# **LEDGE ROAD 4-LOT SUBDIVISION PLAN**

SB# 01-24

## **STAFF REPORT**

June 12, 2024

PROJECT #632 SHEET 4 of 10

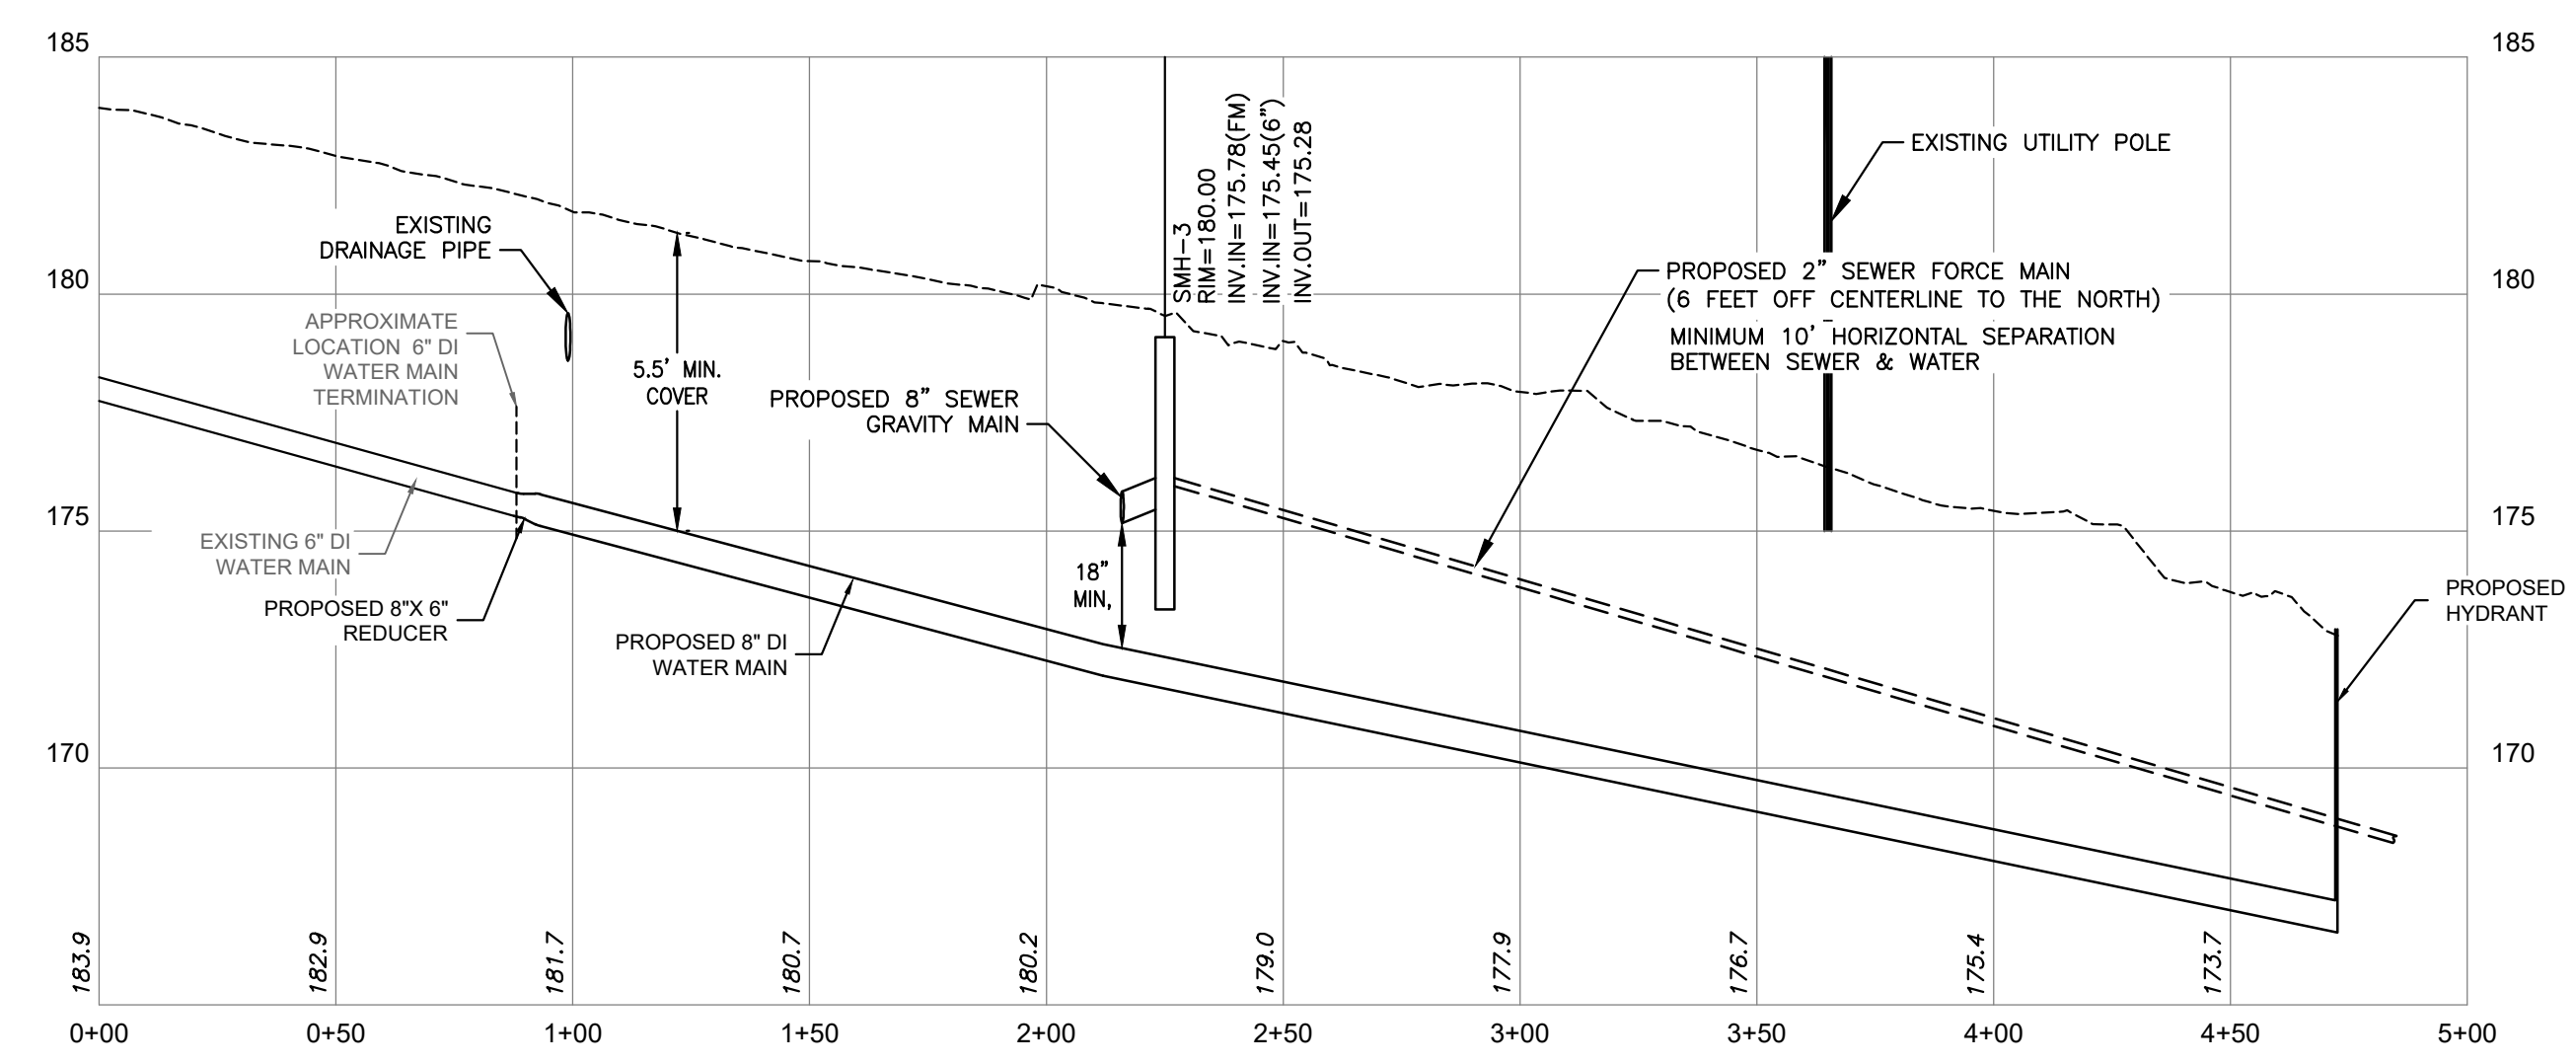
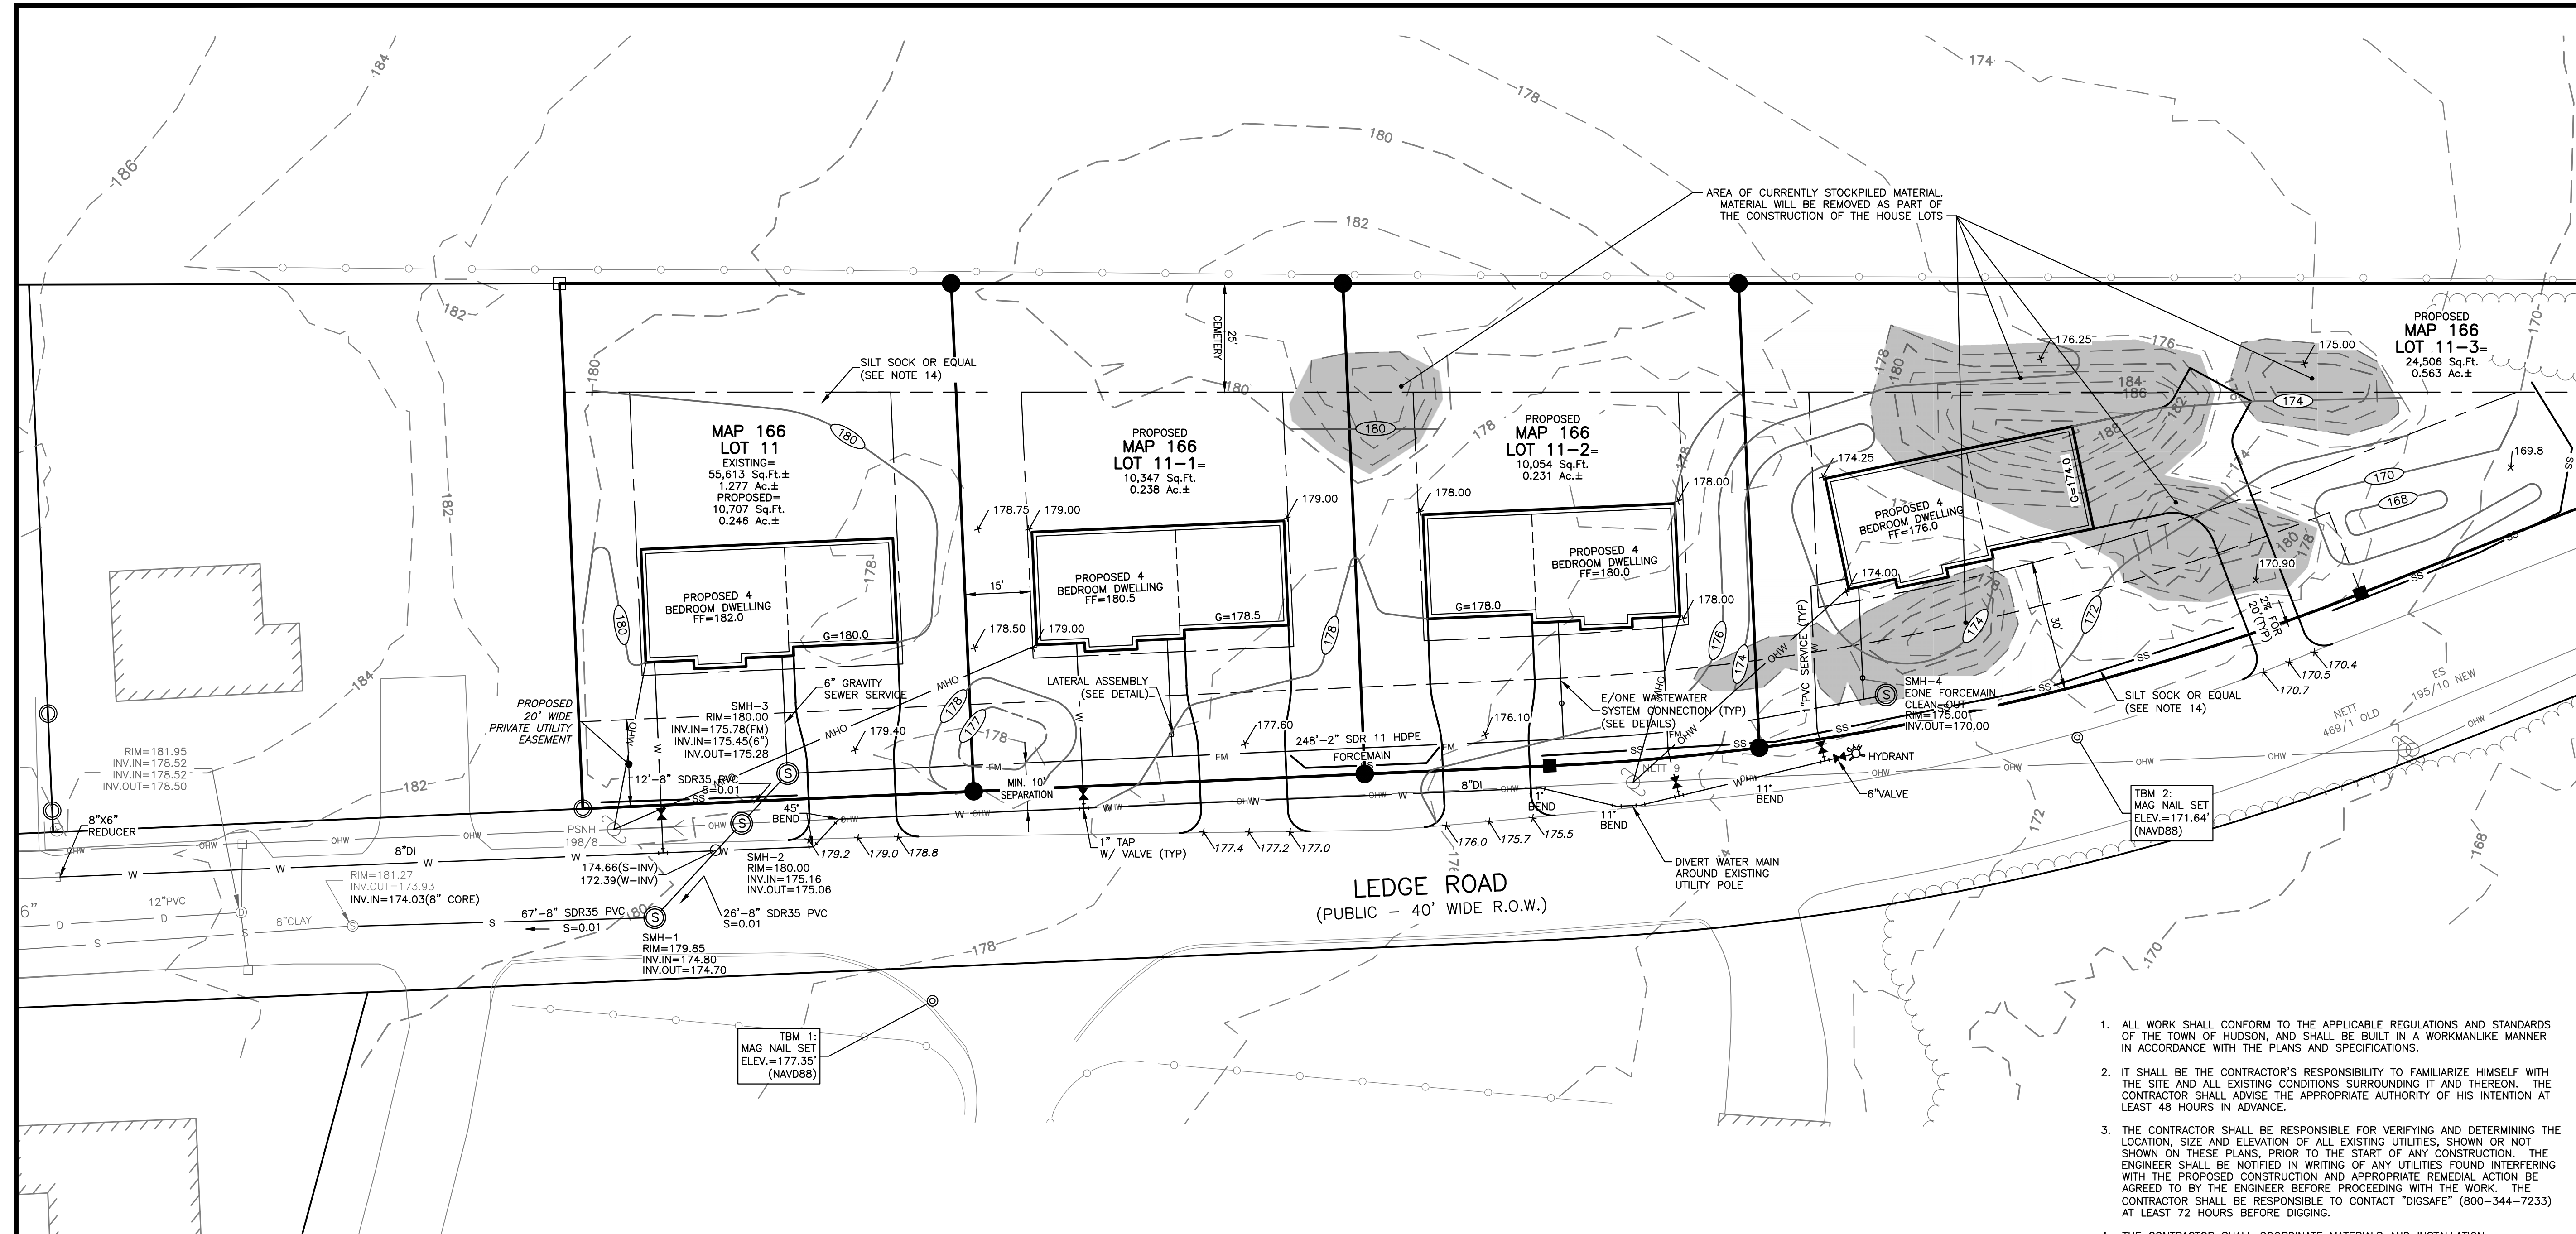
- 1. Applicant shall replace the 8x6 anchor tees with regular 1” tap for the domestic services.*
- 2. Applicant shall increase the slope of the sewer main from SMH 1 to SMH 2 to 1 % min.*
- 3. Applicant shall provide a sewer cleanout for proposed Lot 11.*
- 4. Applicant shall require a water line extension approval, subject to BOS approval, prior to issuing the first building permit.*

*The revised plans indicate a 1 foot deep “hole” between lot 11 and 11-1 , no improvements on Lot 2, some kind of swale around the proposed house on 2 foot deep basin on Lot 4. All the proposed measures appear unpractical and will result in issues in the future. We do not recommend approval of this subdivision until drainage item has been addressed. If the Planning Board approves it as is, all the future complaints about these lots will be sent to the Planning Board to deal with.*

The revised plans indicate a 1 foot deep "hole" between lot 11 and 11-1 , no improvements on Lot 2, some kind of swale around the proposed house on 2 foot deep basin on Lot 4
